CITY OF ROCHESTER COUNCIL AGENDA COUNCIL/BOARD CHAMBERS GOVERNMENT CENTER 151 4TH STREET SE

MEETING NO. 21 REGULAR

SEPTEMBER 3, 2003 7:00 P.M.

Holy Anargyroi Saints Kosmas and Damianos

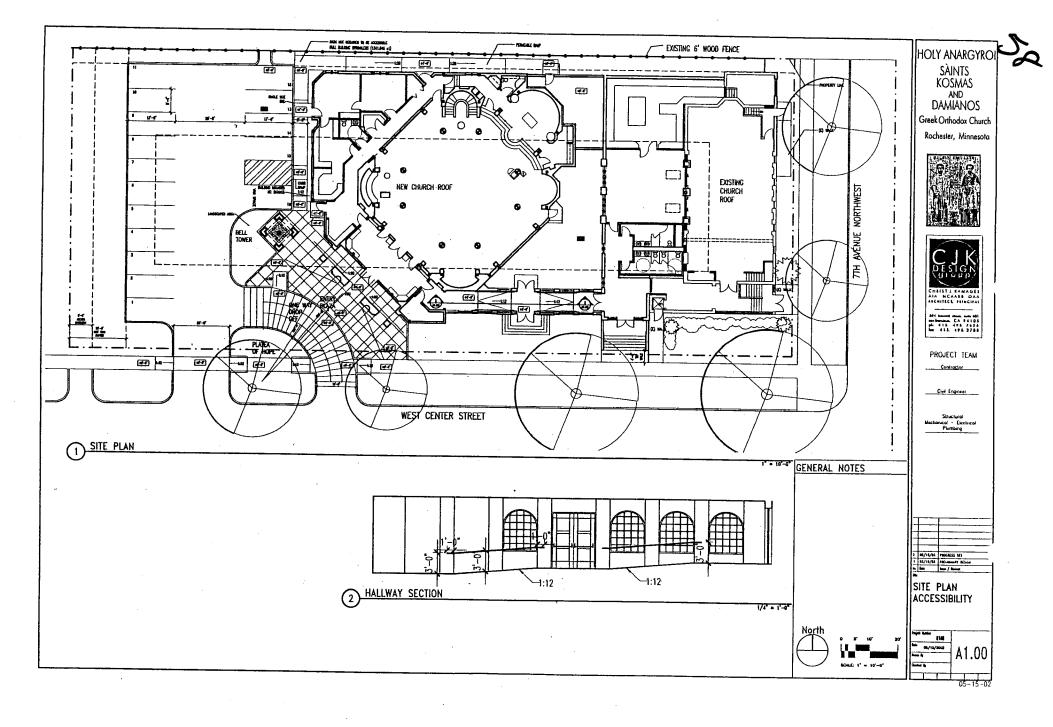
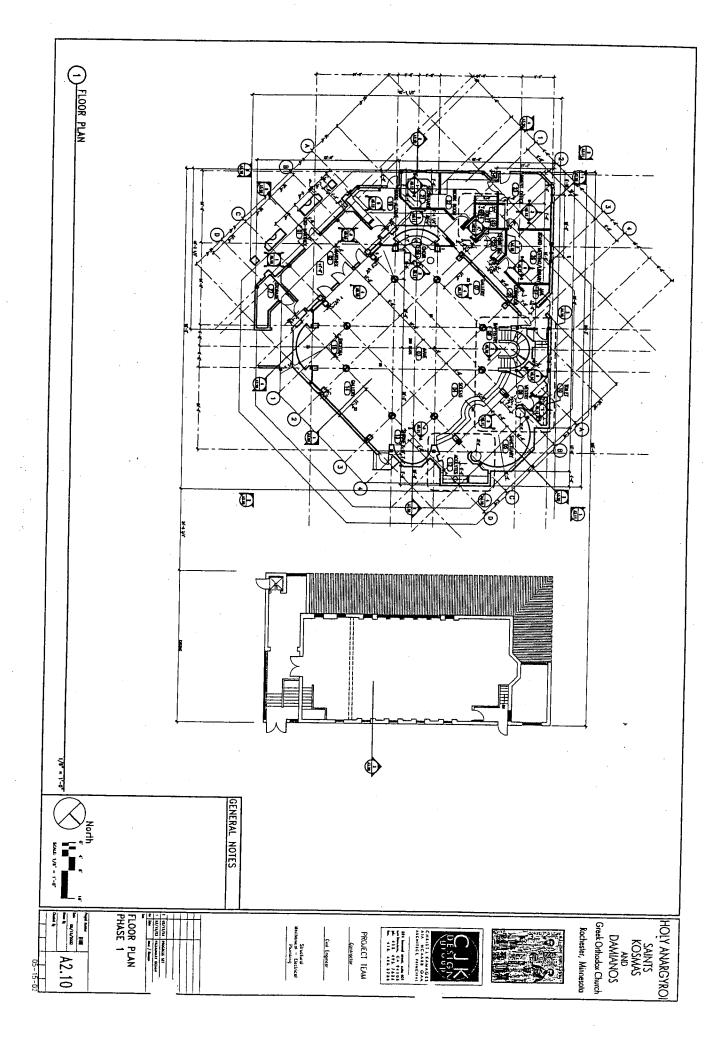
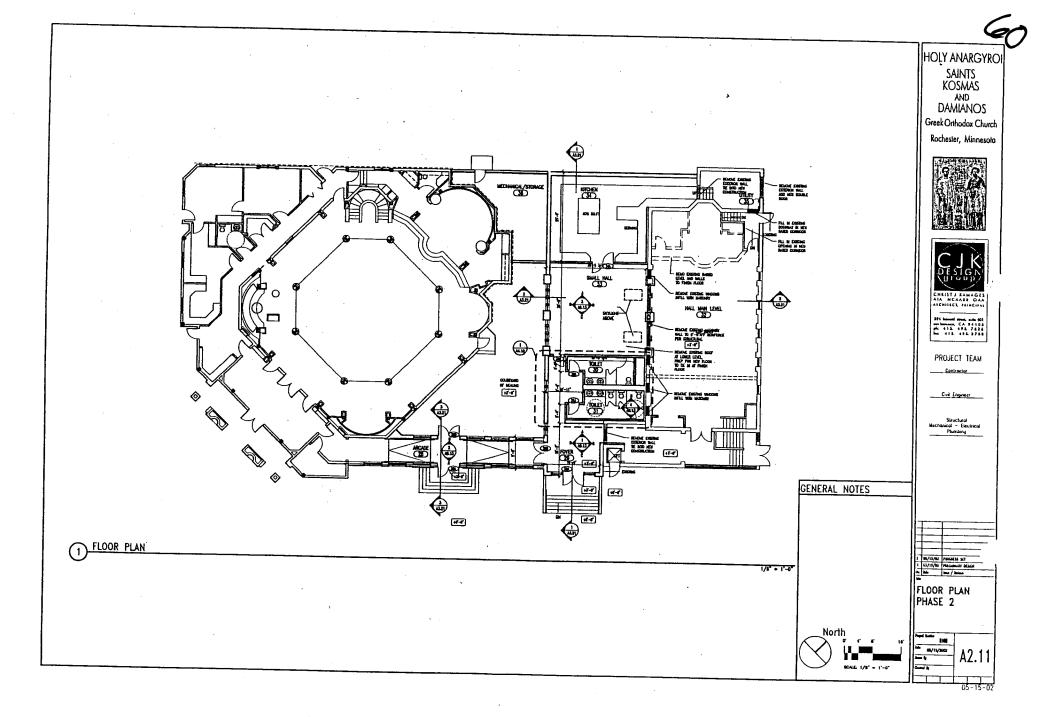
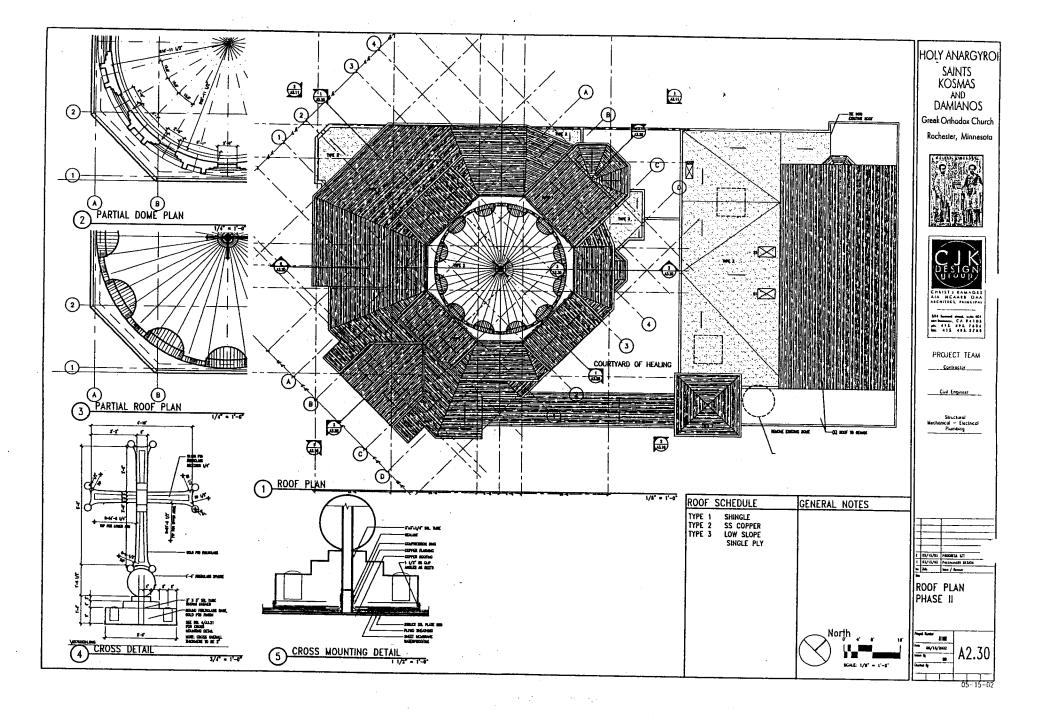
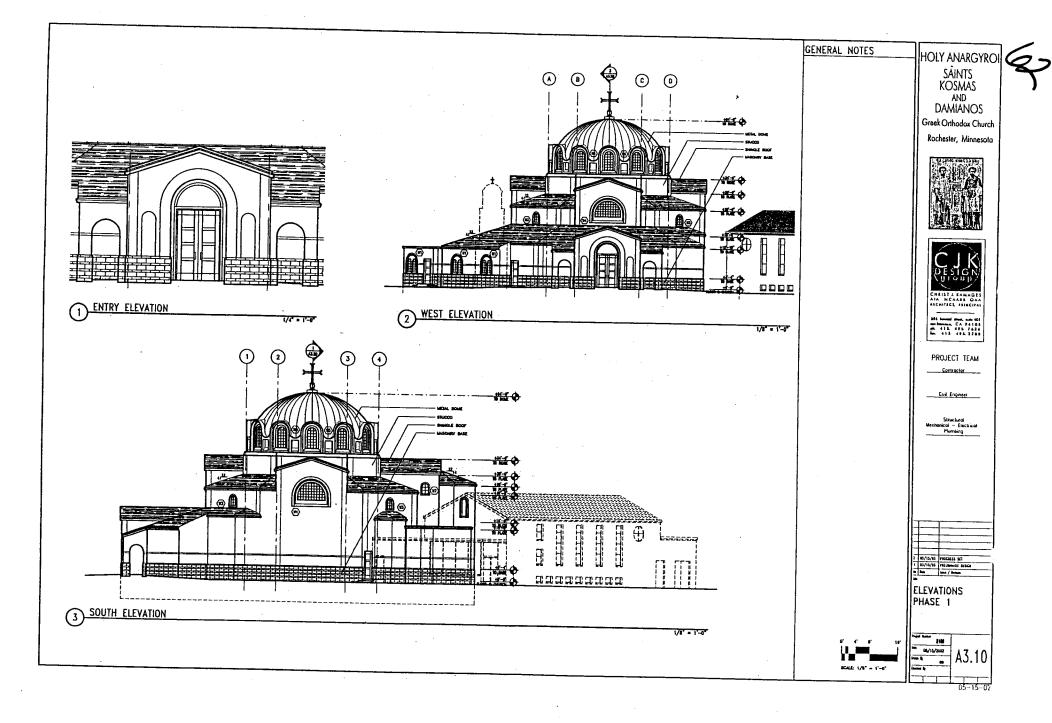
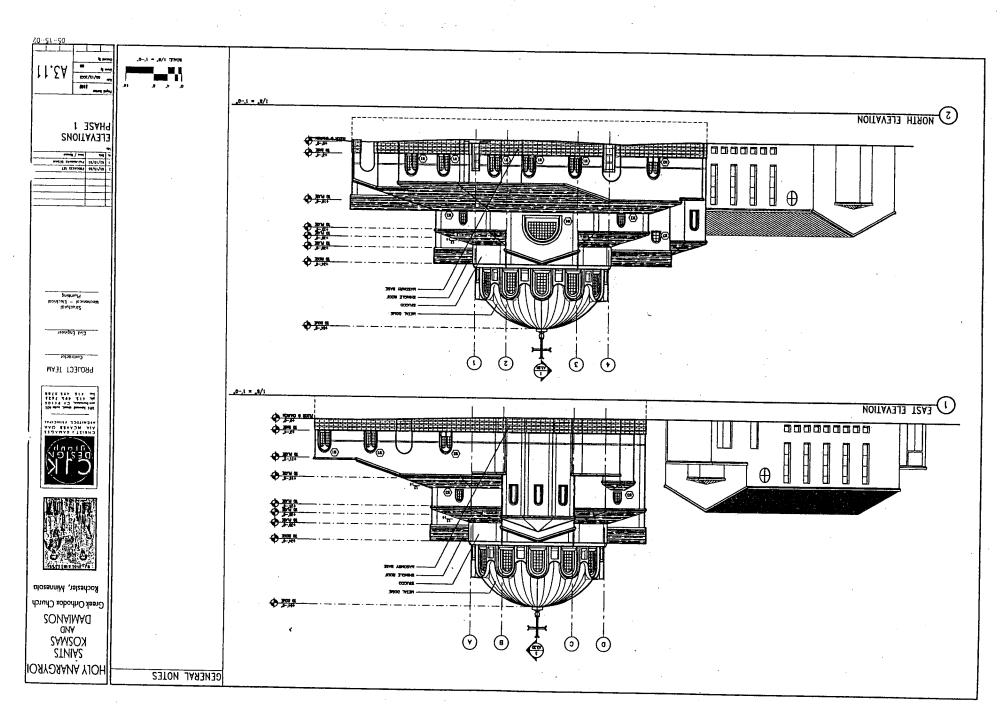
- 8) Screening and Buffering: The project consists of providing a bufferyard meeting the requirement for a "C" bufferyard along the westerly property boundary. One additional deciduous tree will need to be planting along West Center Street. There is an existing 6-foot high wood fence along the north property boundary, which will remain. In addition to the required bufferyard plantings, landscaping will also be provided throughout the property.

The maximum height permitted for an Area Accessory Development is 50 feet. The proposed height of the dome is 54 feet. The applicant has filed a variance of 4 feet to accommodate the height of the dome. The cross on top of the dome can be approved through a Type I Design Modification. Also the proposed modification encroaches into the setback area. Area Accessory Developments have a setback of 30 feet from property boundaries. The existing church already encroaches into the setback areas (25 feet on the north, 24 feet on the east and 16 feet on the south). Also the project provides 24.4% of landscape area, currently the site only has 19.05% landscape area. The minimum amount of landscape area is 30%. The proposal provides more landscape area than what currently exist on the property.

- 1. The Plan shall be revised to provide one 2-way access point or two 1-way access points. It would be logical to have the far easterly access point be a one-way in access and then the next access point to the west an exit only access.

Rochester, Minnesota Rochester, Minnesota CONTEXT INFO

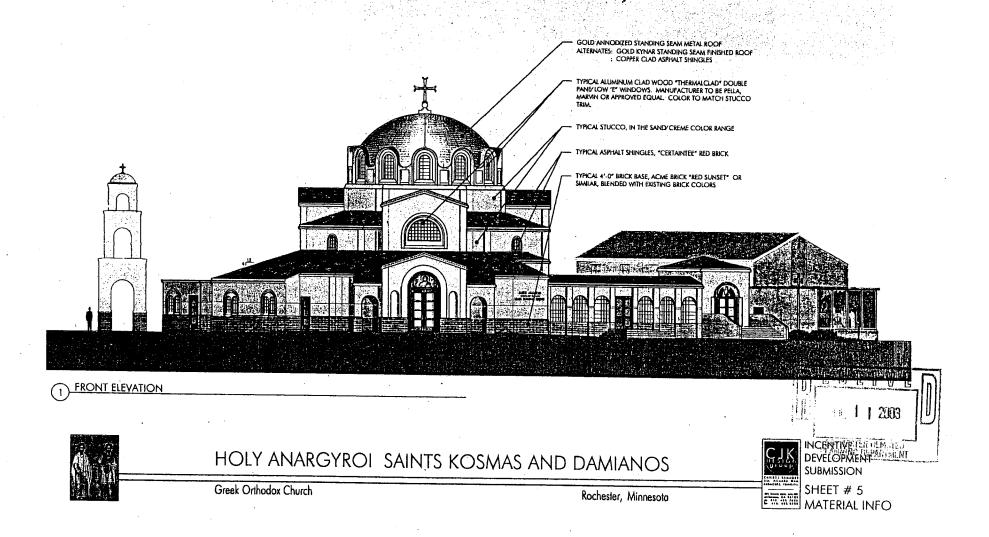
required has been submitted concurrent with the application. The flat nature of the existing site is depicted in the elevations and photographs on Sheet 4, Context Info. of the Incentive Submission.
